*an addition to
Wichita, Sedgwick County, Kansas
February, 1999*

RE: S/D 9894 -- One-Step Final Plat of ROADHOUSE BLUES ADDITON

STAFF REPORT
(One-Step Final Plat Approved 10/22/98)

CASE NUMBER: S/D 98-94 - ROADHOUSE BLUES

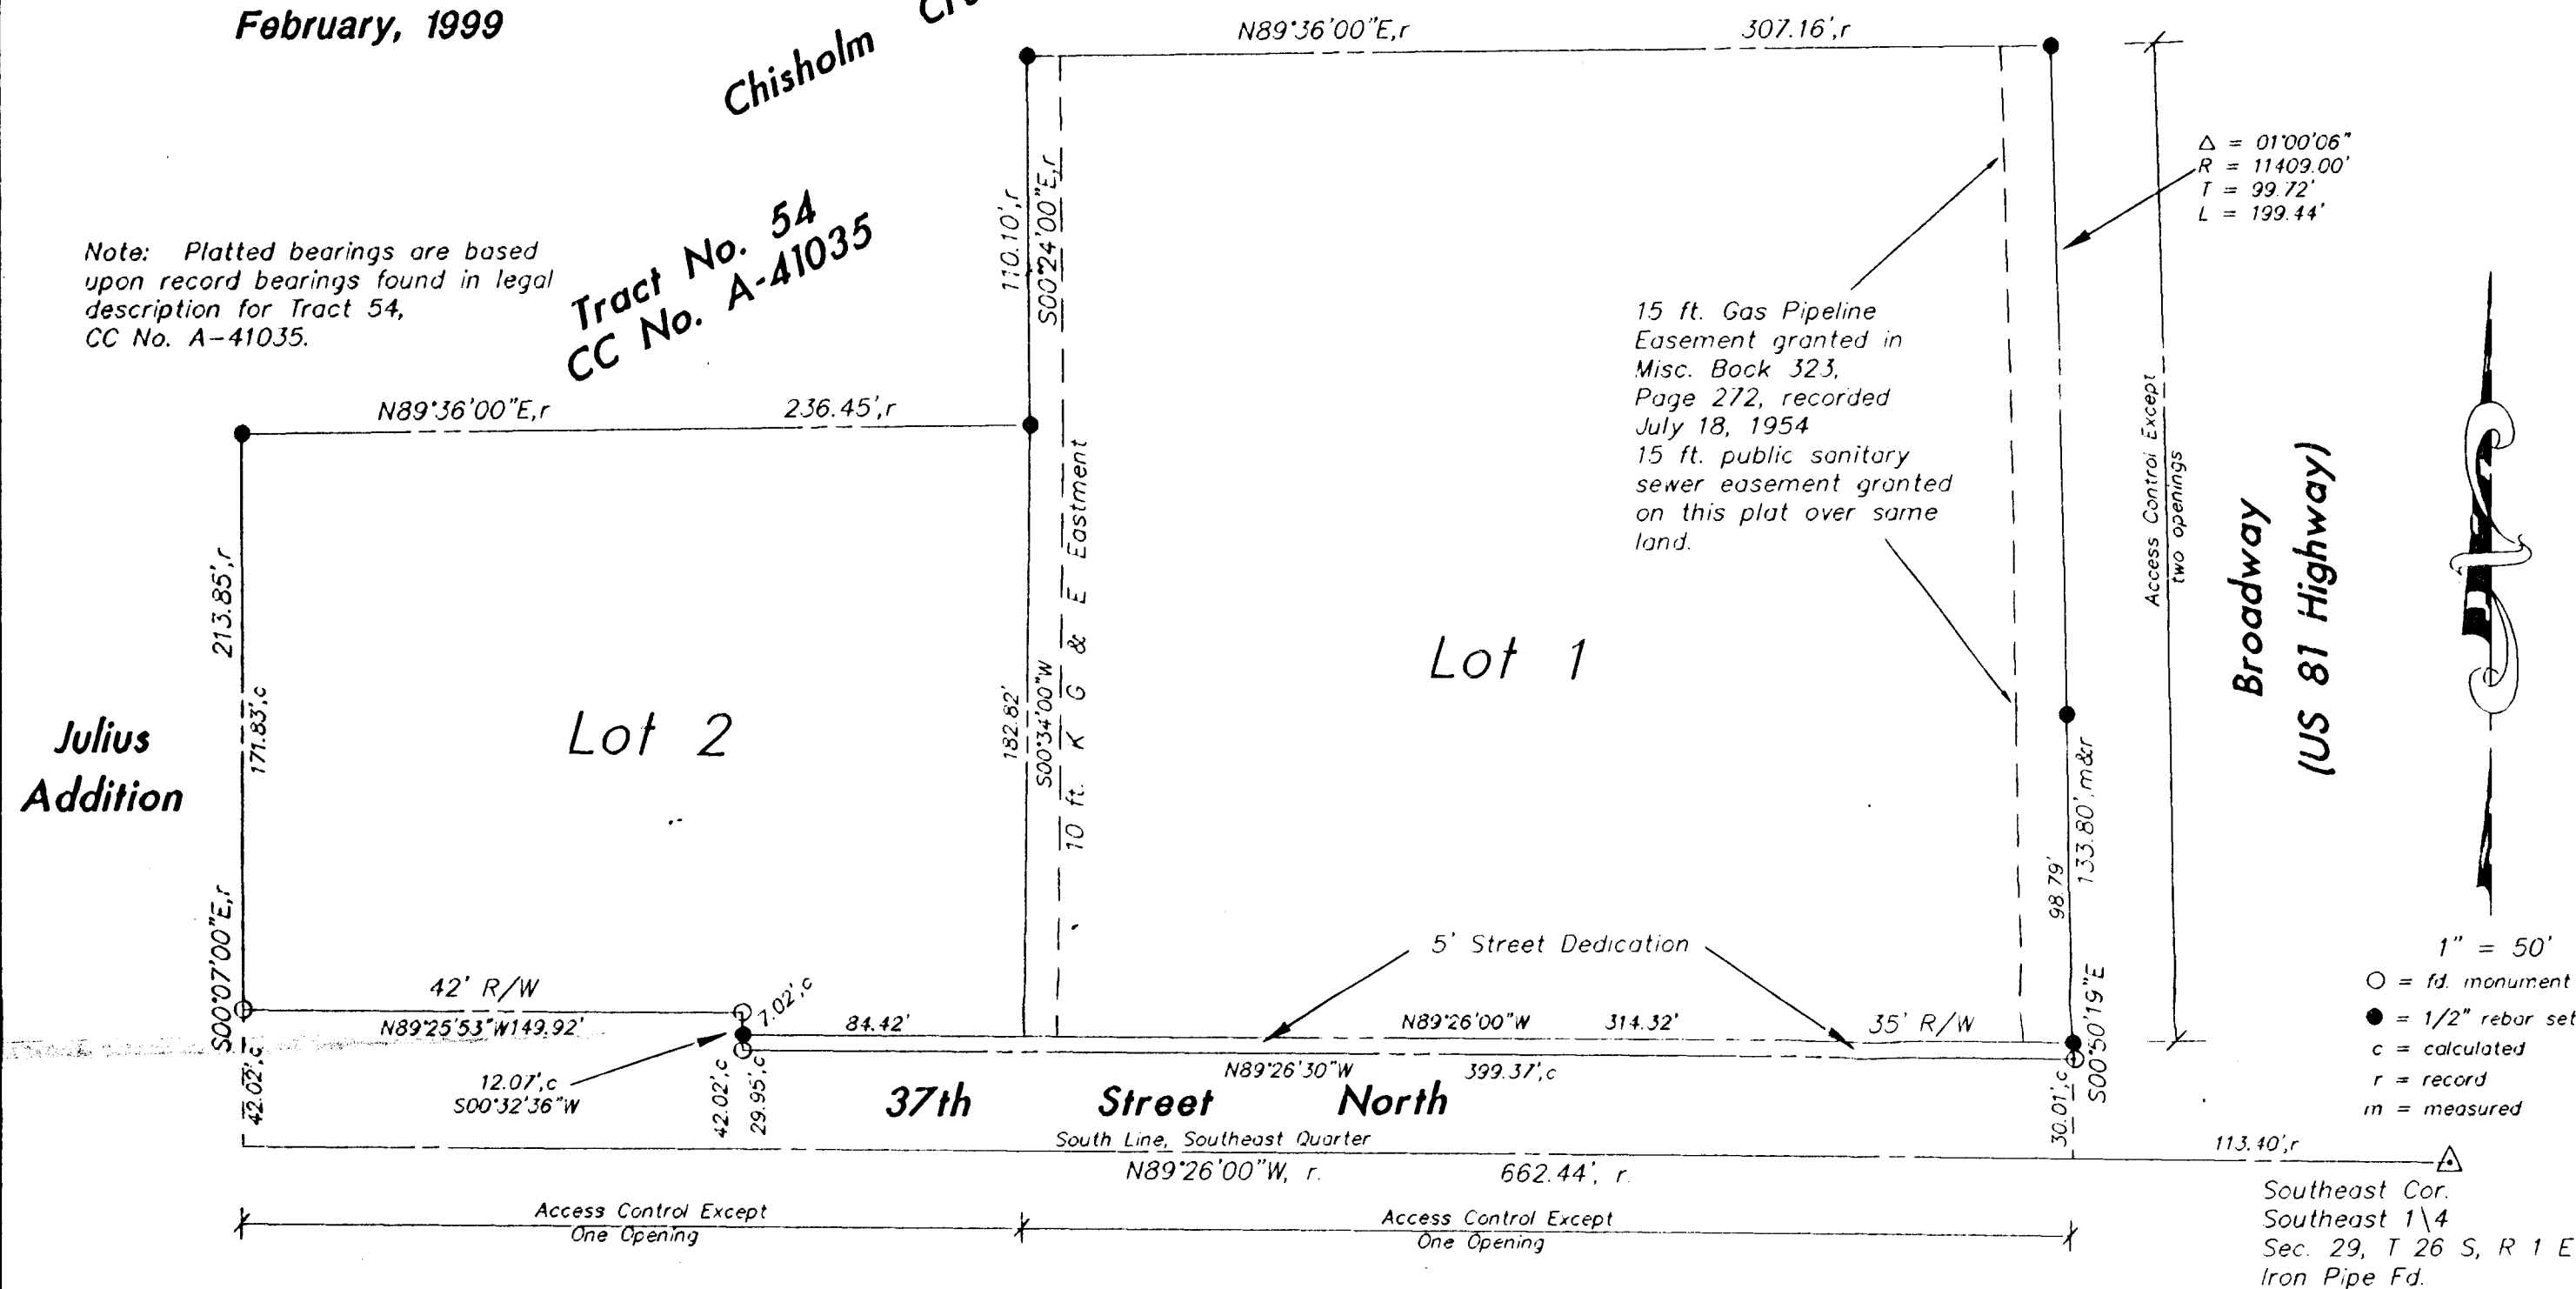
- E. The subdivision regulations encourage shared access points for multiple lot industrial subdivisions along arterials. Traffic Engineering needs to comment on the need for a joint access along 37th St. North in addition to access controls along Broadway. The dedication of access controls shall be referenced in the plat's text. Traffic Engineering has approved two access openings along Broadway and one opening per lot along 37th St.

- F. Traffic Engineering needs to comment on the need for additional right-of-way for 37th St. North. Any such dedication shall be referenced in the plat's text. *An additional five feet of right-of-way needs to be dedicated along 37th St. North, along the portion which currently contains 30 feet of half street right-of-way.*

- G. The MAPC Chairman needs to be revised to read William M. Johnson.
- H. Since the site is located within the City, County Commission approval is not needed and the County signature block on the plat may be eliminated.

- I. The Applicant is advised that a 20-ft building setback will apply, but is not required to be platted. The 35-ft building setback platted for lot 2 may be eliminated.

- G. The MAPC Chairman needs to be revised to read William M. Johnson.
- H. Since the site is located within the City, County Commission approval is not needed and the County signature block on the plat may be eliminated.

- I. The Applicant is advised that a 20-ft building setback will apply, but is not required to be platted. The 35-ft building setback platted for lot 2 may be eliminated.
